# **FINAL-MY1 Monitoring Report**

## **Seniard Creek Mitigation Site**

**NCDMS Project No. 100017**

Subject: Draft MY1 Monitoring Report  
Seniard Creek Site, Henderson County  
French Broad River CU 06010105  
DMS Project ID No. 100017 / DEQ Contract #7189

This map is not a survey and is not to be construed as such.

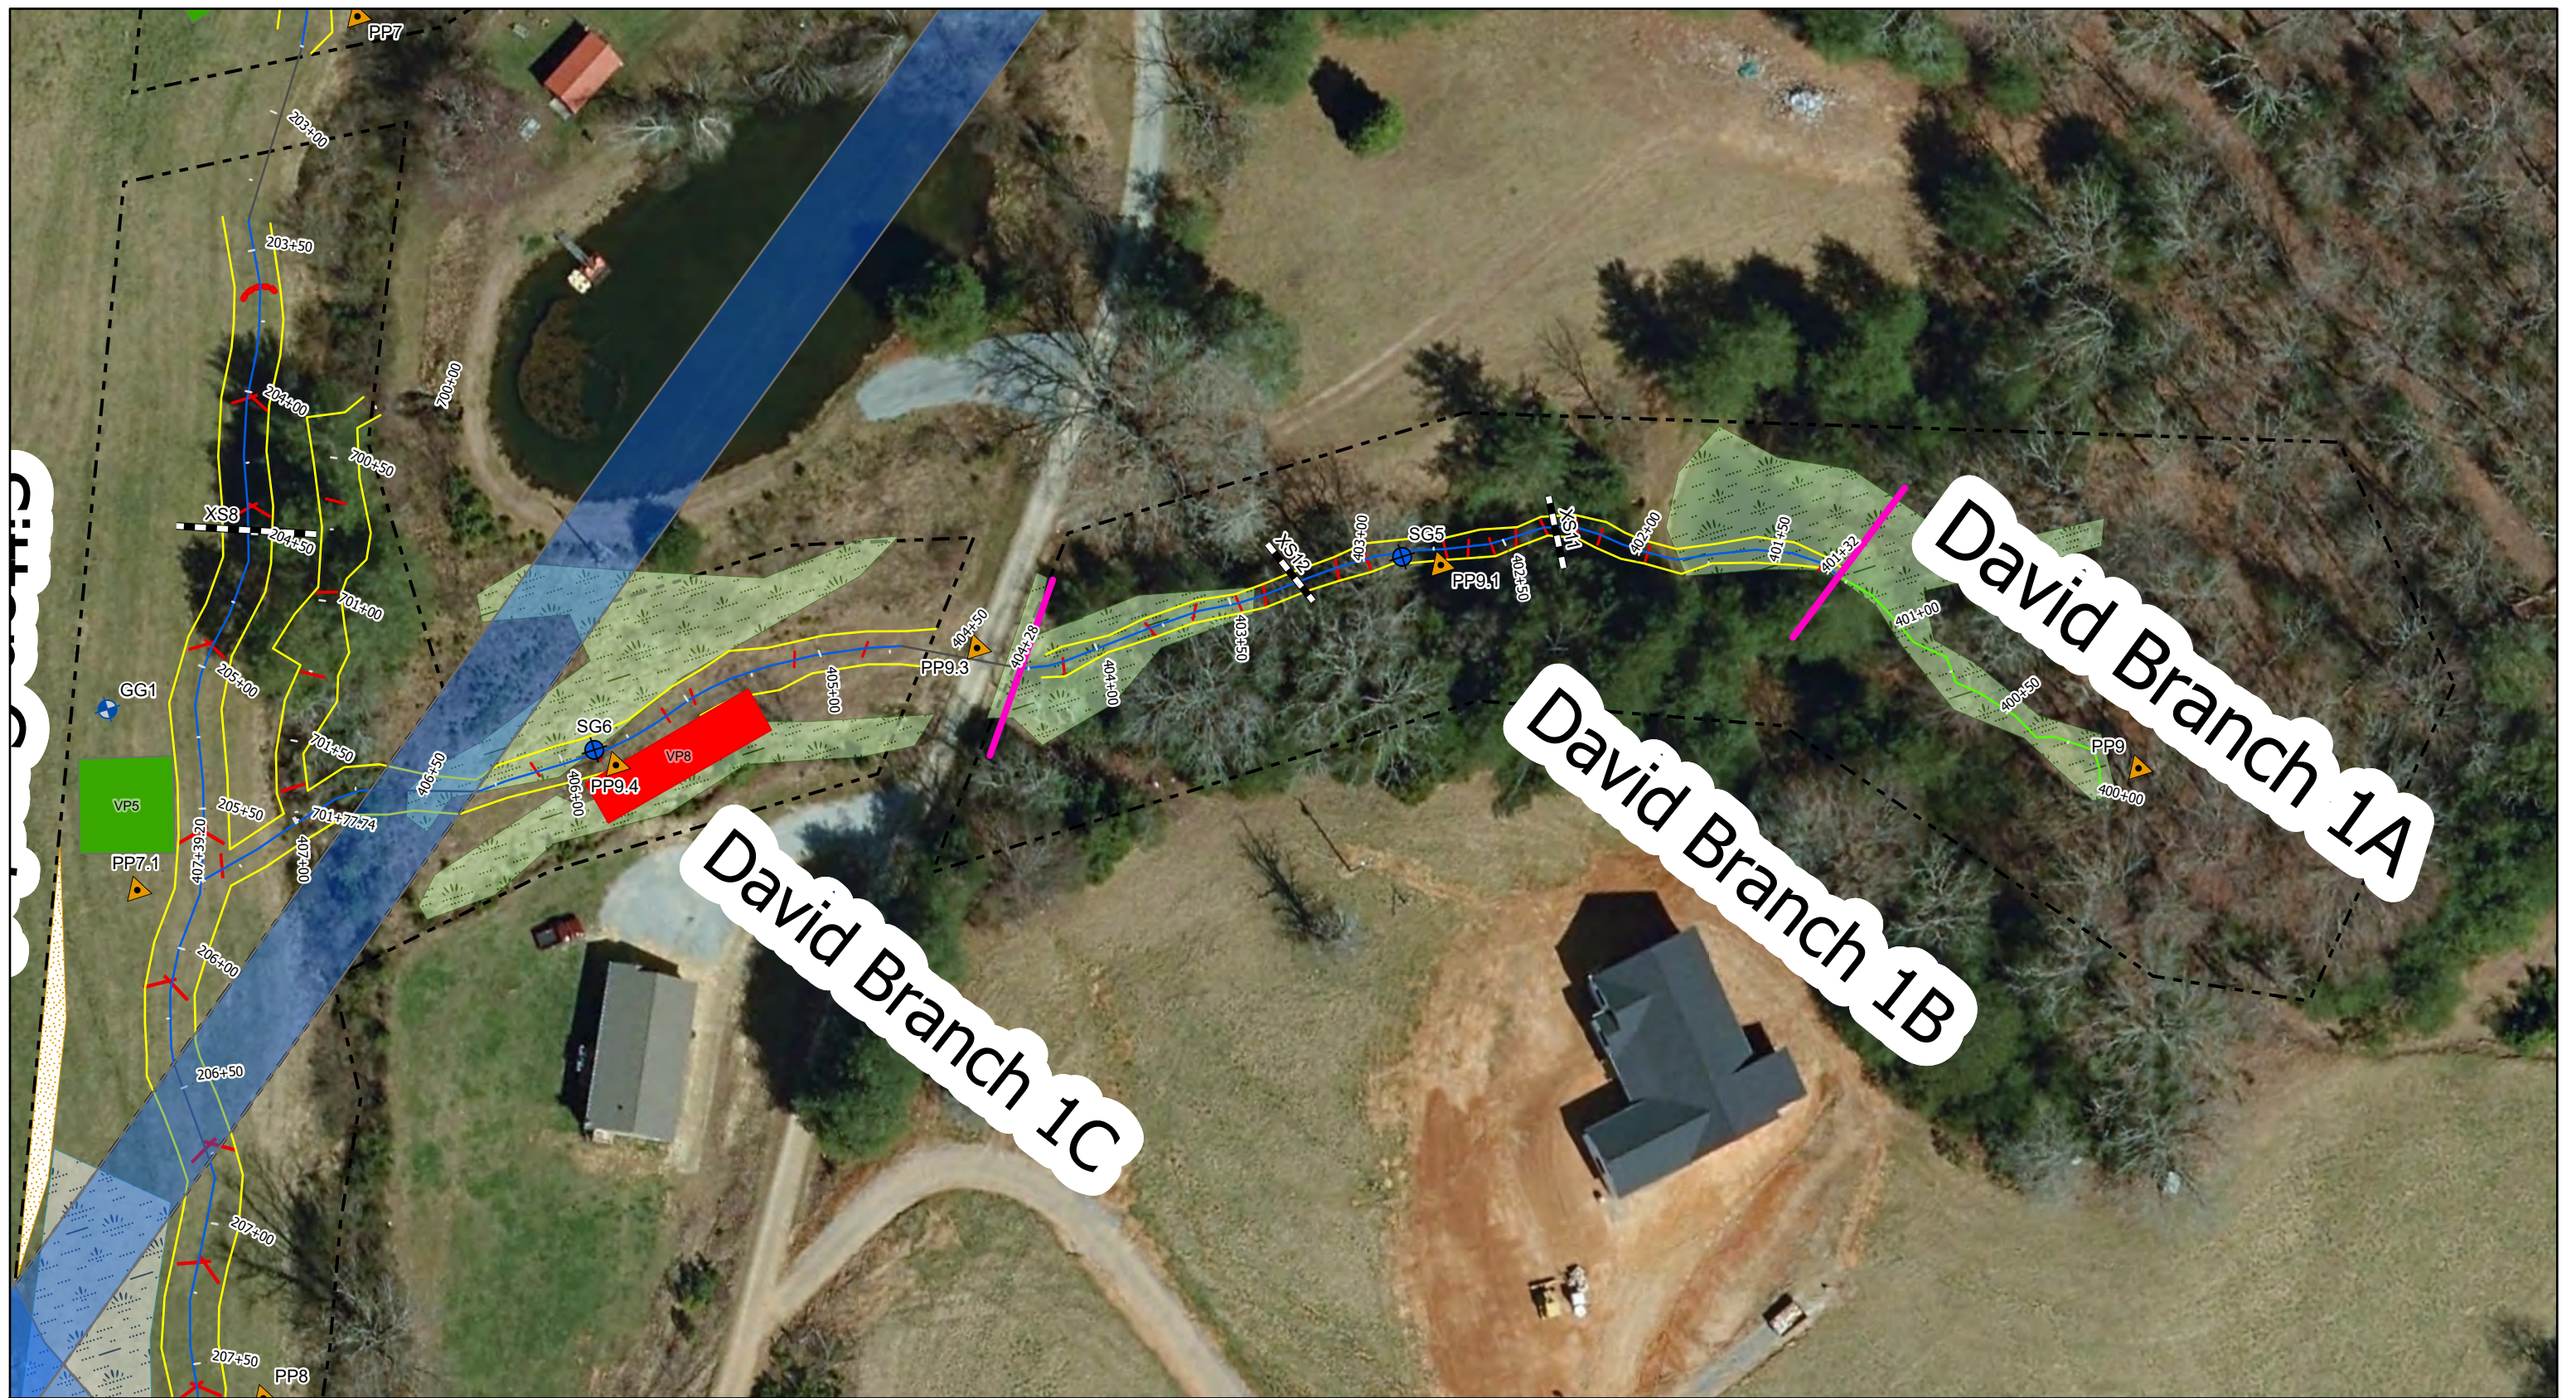
- During a recent site visit (Nov. 2021) by DMS there were a couple areas of low stem density and easement mowing/scalloping not showing on the CCPVs; please see PDF map attached to this email, acknowledge, and take these areas into consideration during the 2022 (MY2) assessment. There are also other boundary item comments and concerns noted that I would like your feedback on during the upcoming monitoring year. **We have reviewed the areas mentioned and will reassess them during MY2 monitoring. We will continue to address all boundary item comments and concerns.**

- Vegetation plots not meeting criteria (VPs 8 and 9) should be coded a different color (typically orange or red) than those meeting (green) on the CCPVs. **Coding added.**

Client/Project: EW SOLUTIONS, LLC  
SENIAID CREEK MITIGATION SITE  
HENDEKSON COUNTY, NC  
Title: PLANTING DETAILS - AS-BUILT

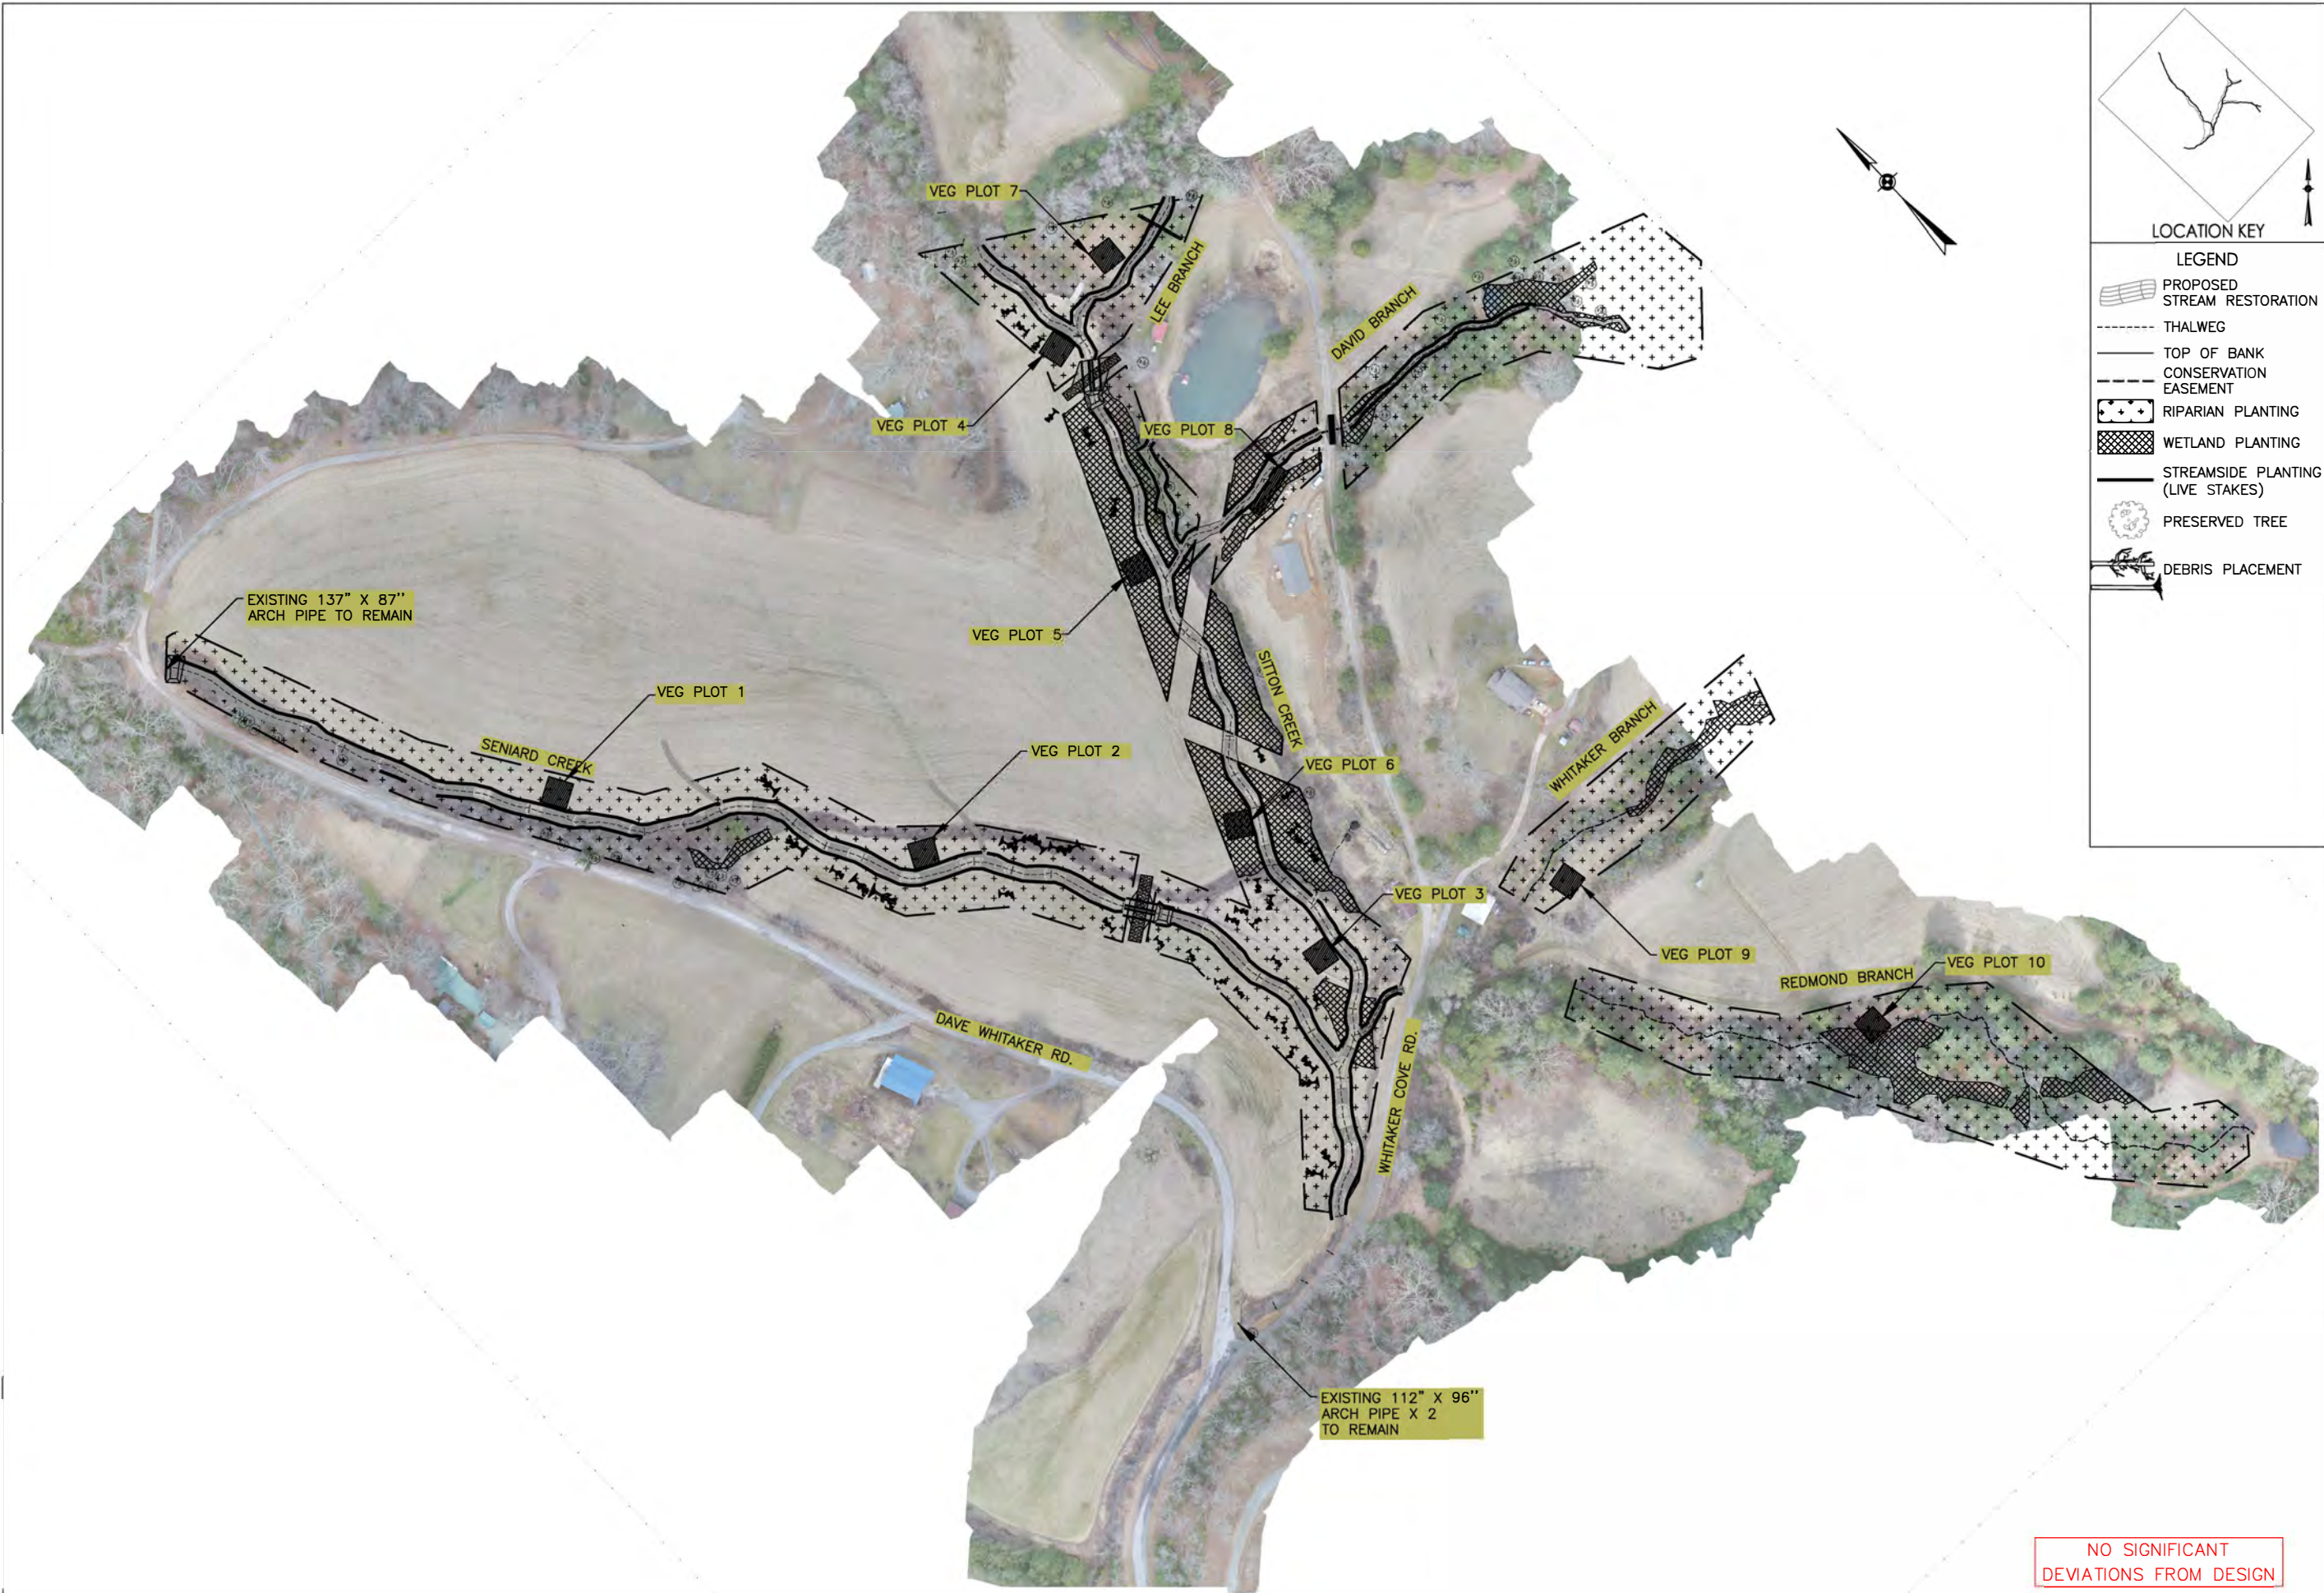
- b. It appears that shagbark hickory, mockernut hickory, and shingle oak were not part of the original approved mit plan plant list; however, the redline did not reflect any changes in the species/quantities; it is understood that these will be part of a mitigation plan addendum but because they have already been planted they should be annotated on the redline. Where were these species planted? Throughout the entire site? They only appear in veg plot 7. The topography of the project area required those more upland species to be planted along the fringe of the easement including Veg Plot 7. A redline document indicating modifications to the plan will be included as an

c. We appreciate green ash being removed from the planting plan. Andrea Leslie also provided feedback on the planting plan stating that river birch is only appropriate on larger systems in the mountains, and requested it to be removed. If you have a good ecological reason to plant river birch on the site, please provide that justification. In general, river birch is a more dominant species on larger river alluvial systems; however, it is a significant existing riparian component within the North Mills River and the surrounding project area. As such, it was included in the plantings.

A deviation from the planting design which was not submitted as part of the redline package was identified in the MY0 report. This deviation consisted of the addition of three species of tree *Carya glabra*, *Carya tomentosa*, *Quercus imbricaria*; and the redaction of *Fraxinus pennsylvanica*. This updated redline drawing is located in Appendix F.
